EDUCATION VILLAGE PARCEL E & F

SUMMARY

MASTER PLAN ANALYSIS

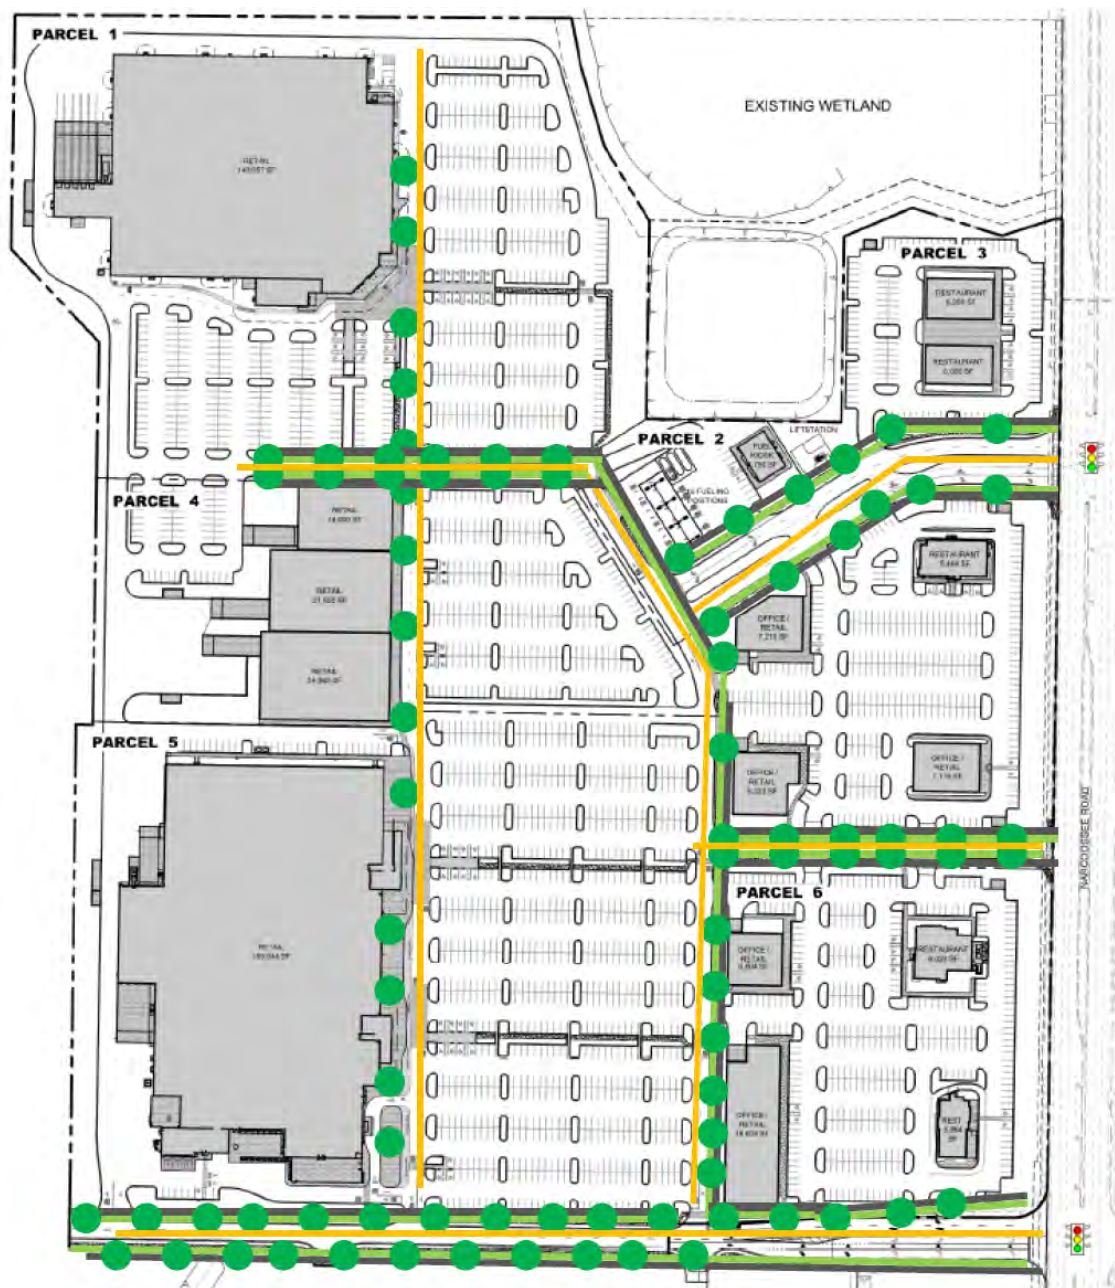
Aerial photos show existing trees south of the retention pond. Consider moving the Parcel 2 Gas Station and replace with a restaurant or other outdoor use that can benefit from tree cover.

According to LDC Section 61.221(a), it states that “development shall provide multiple direct vehicular and pedestrian connections in its local street system and internal circulation to and between nearby local destinations, such as transit stops, parks, schools, residences, workplaces and shops, without requiring the use of arterial streets.” Urban Design Condition #12(b) of this report states, “A minimum of one pedestrian connection shall be provided from each parcel (as depicted on the exhibit provided identifying each parcel) from each public or private street, to the main entrance of each building. Multiple tenant buildings may consolidate to one connection if cross connections are provided.” And Urban Design Condition #12(e) states, “The main vehicular drives, pedestrian areas in front of the large retail stores, and the north/south vehicular drives between parcels 5 and 6 shall be designed to appear as streets, with street trees within minimum 7 foot wide park strips adjacent to the curb, and a minimum 5 foot wide sidewalk.” The diagram below explains these conditions in graphic form.

PROPOSED SITE PLAN/PRELIMINARY PLAT

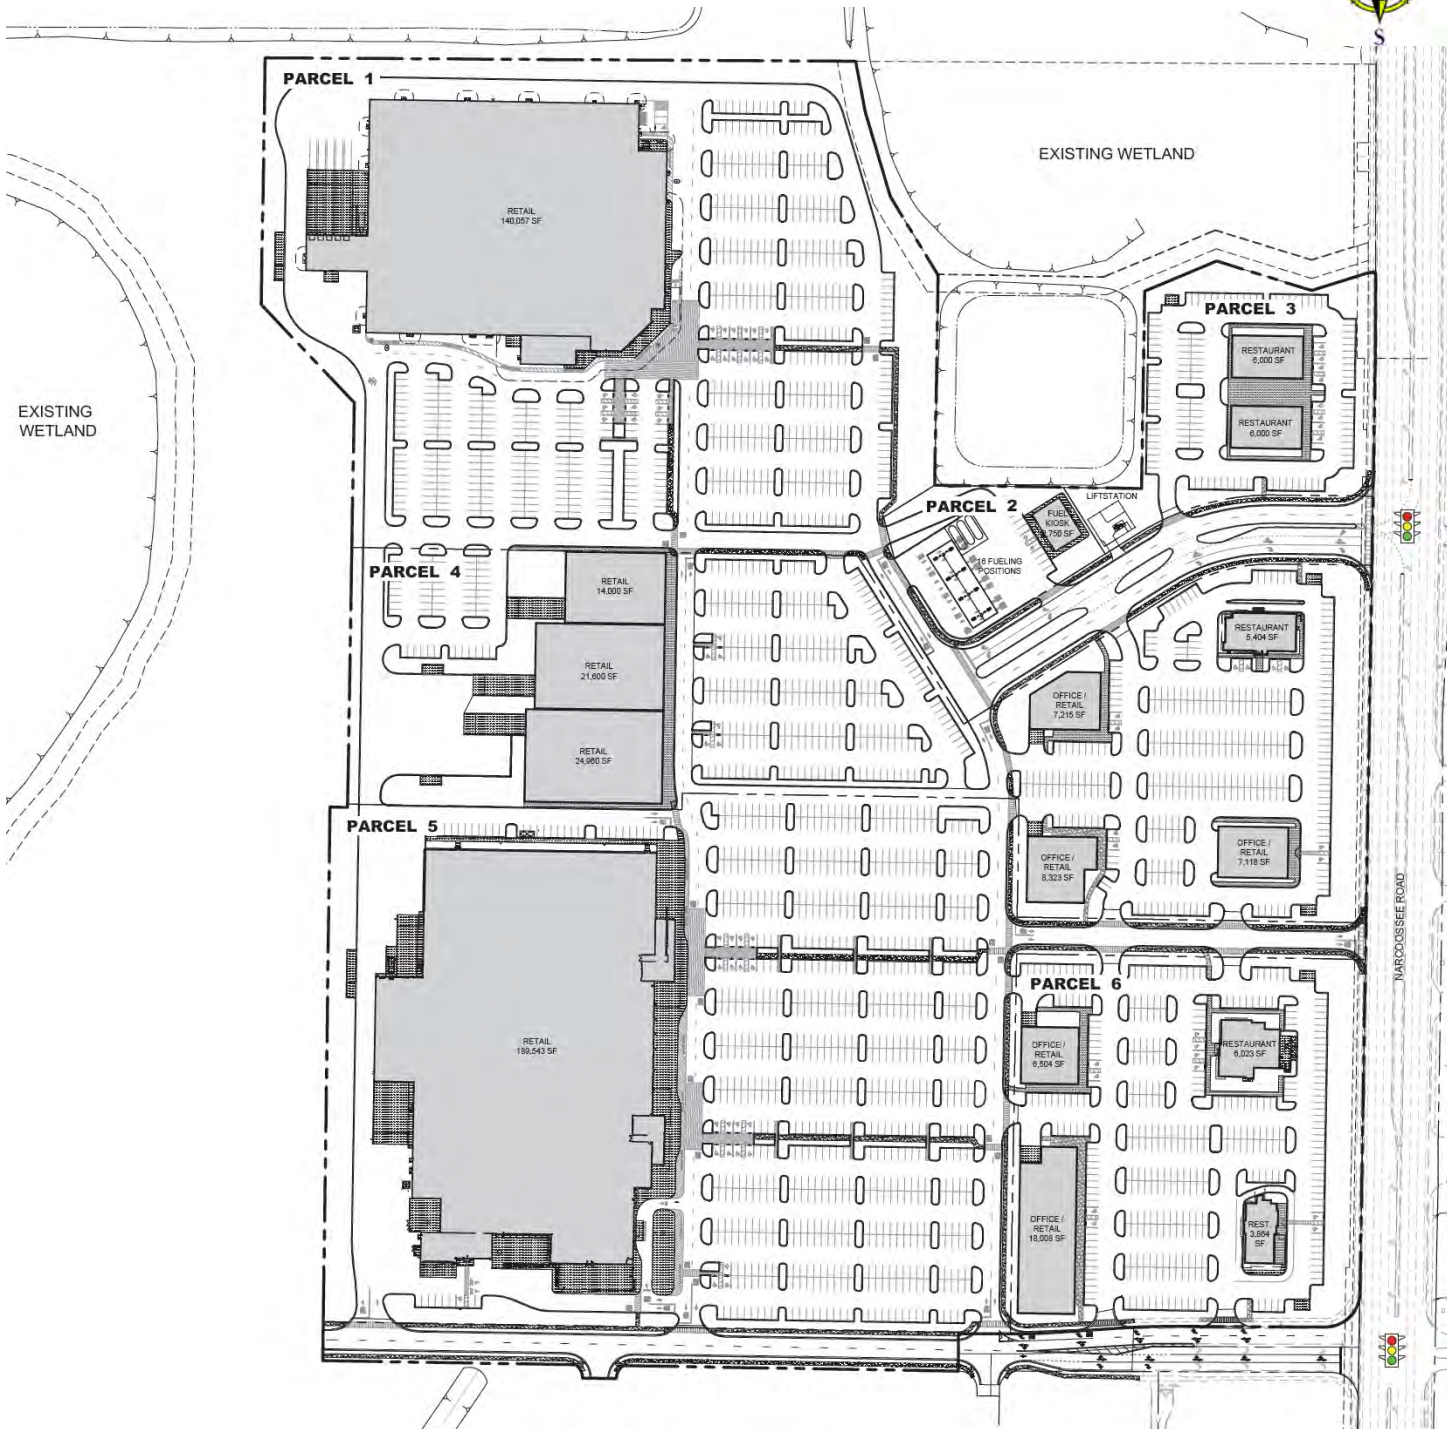
1. Tagore Place shall have a cross section that has three lanes, one lane in each direction running east or west, and one center turn lane. This cross section will begin after the existing concrete center median and continue the length of Tagore Place. A 60 foot wide ROW will be required to accomplish this, currently 55 feet is being proposed.

2. In Parcel 6, the multiple north and south curb cuts will be combined to one and a drive aisle that runs north and south will connect each of the sub-parcels. This will help with circulation of proposed drive-thru's and reduce multiple conflicts on interior roads.

3. The curb cut on Tagore Place from Parcel 6 shall be a right-in/right-out only. A physical barrier shall be placed at the driveway to accomplish this.

6. Realign the center drive aisle on the north side of Parcel 6 that runs perpendicular from Narcoossee Rd, this can be accomplished by decreasing the size of the median on the eastern side of Parcel 5 or by increasing the offset to create a "T" intersection.

ARCHITECTURAL ELEVATIONS—PARCEL 5

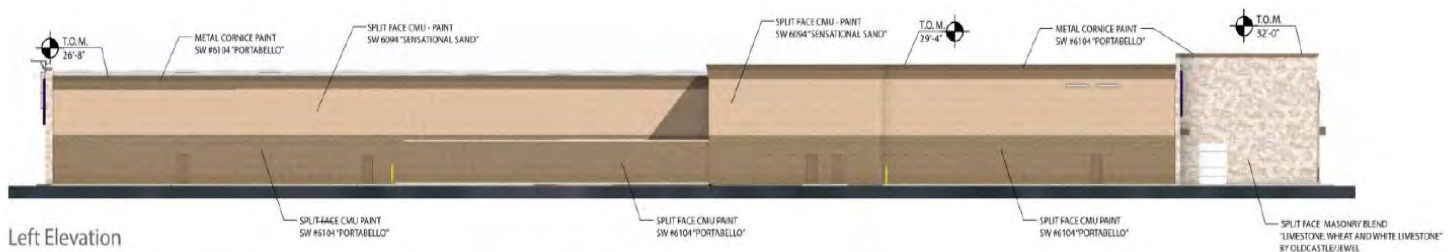
Elevations were provided for the grocery store and bulk-retail store. All other retail buildings and out parcels shall require an appearance review through Planning Official determination prior to submitting to Permitting.
